CITY PLANNING COMMISSION
 1231 "I" STREET, SUITE 200, SACRAMENTO, CA 95814

- APPLICATION:**
- A. Negative Declaration
 - B. Rezoning of 8+ vacant acres from Agriculture to Multiple Family-Review (R-2B-R).
 - C. Plan Review of a 168 unit apartment complex on 8+ vacant acres in the proposed R-2B-R zone.

LOCATION: Northeast corner Franklin Boulevard and Calvine Road

PROPOSAL: The applicant is requesting the necessary entitlements to construct a 168 unit apartment complex.

STAFF MODIFIED SITE PLAN

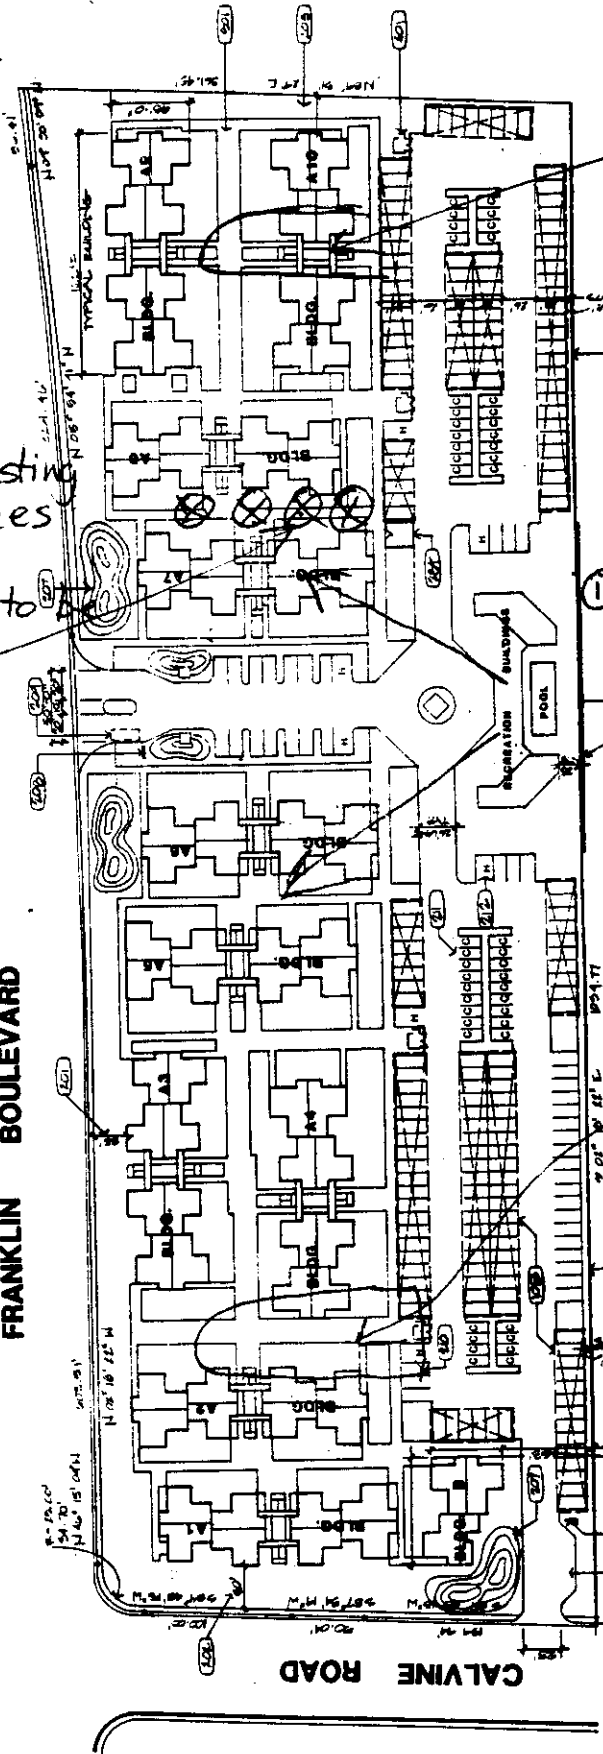
The third tree in from Franklin Boulevard is the largest and healthiest tree and is recommended that it be preserved. The smaller three trees can be preserved or removed. The trees provide a landmark for the site and should be retained if possible when revised drawings are submitted. Staff recommends the relocation of a driveway to the area near the trees so that the trees could serve as a focal point (see staff modified site plan).

14. The site plan should be revised to show parking closer to the units being served. Staff recommends the site plan be revised to show parking areas within 100 to 150 feet of the unit being served (see staff modified site plan).

② Preserve existing Eucalyptus trees if possible, largest tree to be saved.

③ Relocate Parking to be closer to units

① Relocate Recreation facilities to the West

④ Relocate Parking to be closer to units

12. Recreational facilities shall be relocated to the west away from the eastern property line as shown on the staff modified site plan. Recreational facilities shall be closed between the hours of 10:00 p.m. and 7:00 a.m. with signs posted at the facility.

19. The applicant shall revise the site plan to preserve the four existing eucalyptus trees if the City Arborist and Planning Director find that they are worthy of retention. If the trees are to be removed, they shall be shown on the site plan and the City Arborist shall approve their removal.

20. The site plan shall be revised to show parking closer to the apartment units. Suggested locations are shown on the staff modified site plan.
21. The applicant/developer shall comply with all requirements of the negative declaration prepared for the project on file at the City Planning Department regarding noise attenuation for building design P88-444 and as indicated by Exhibit F.

EXHIBIT II

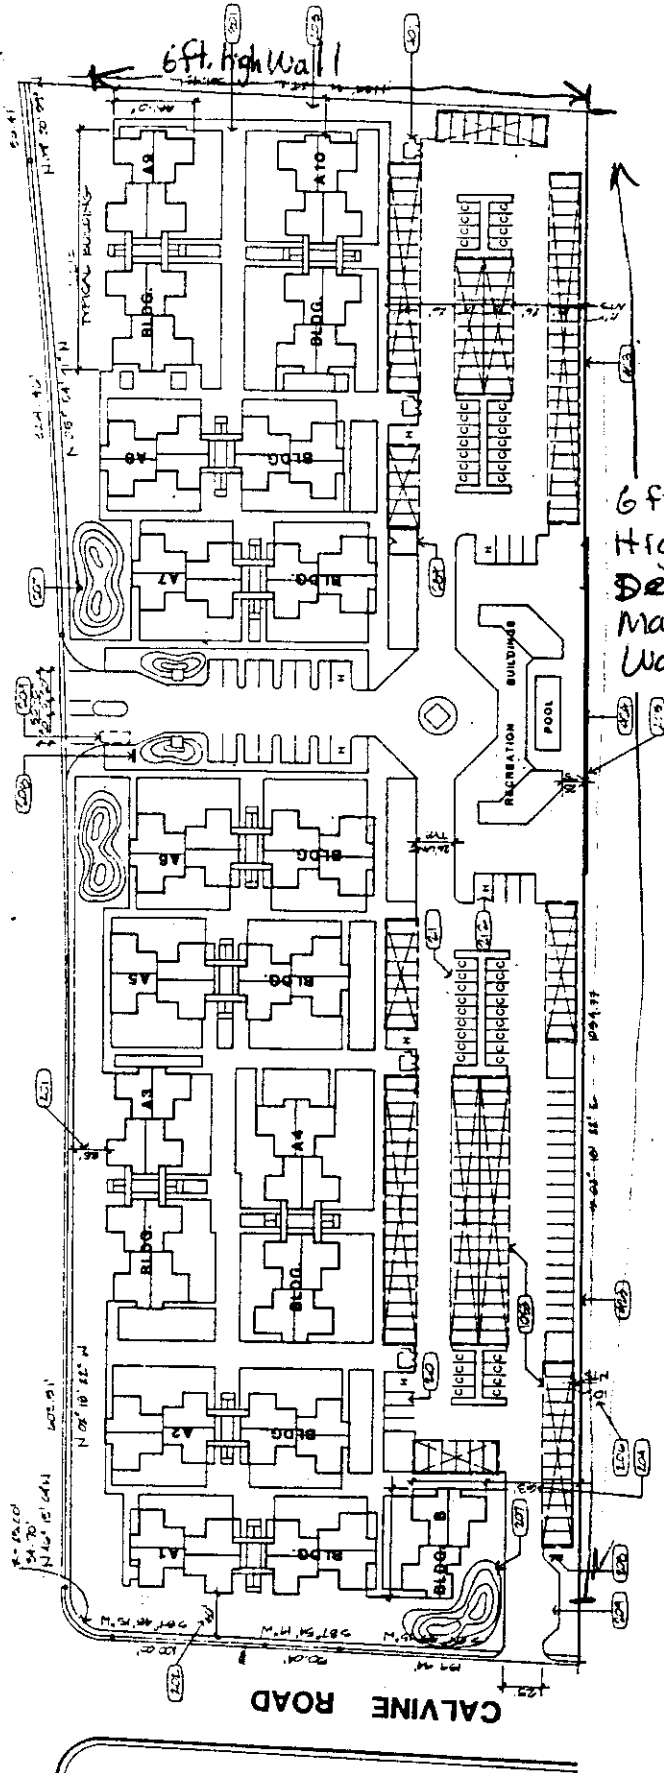
6 ft. to 8 ft.
High Solid
Decorative
Masonry
Wall

6. A six to eight foot high solid decorative masonry block wall shall be constructed along the east and north property lines as indicated in Exhibit E.
